PRODUCT CHANGE NOTIFICATION

Product Identification: Bel 0810 2x4, 2x6, 2x8 ICMs

PCN Number: PC2190078

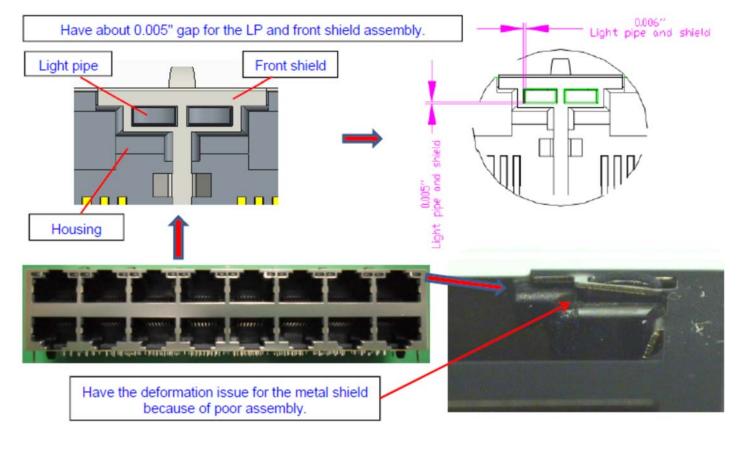
Reason for Change (s): In an effort to continually improve our product, Bel is pleased to announce a modification to the front shield of the 0810 2xN ICMs in the specific area of the light-pipe and front shield. As shown below the gap between the light-pipe and shield is too small and can cause the shield to bend or become misaligned and create a snagging hazard. The solution is to remove the thin window frames from around the inside and bottom of the light-pipe.

Description of the Change (s): To resolve the assembly issue and deformation of the shield around the light-pipe, the thin, shield window frames around the inside and bottom of the light-pipe will be removed. By removing these thin metal pieces, the limited gap issue will be resolved and there will not be a concern for shield deformation. Please see the details below.
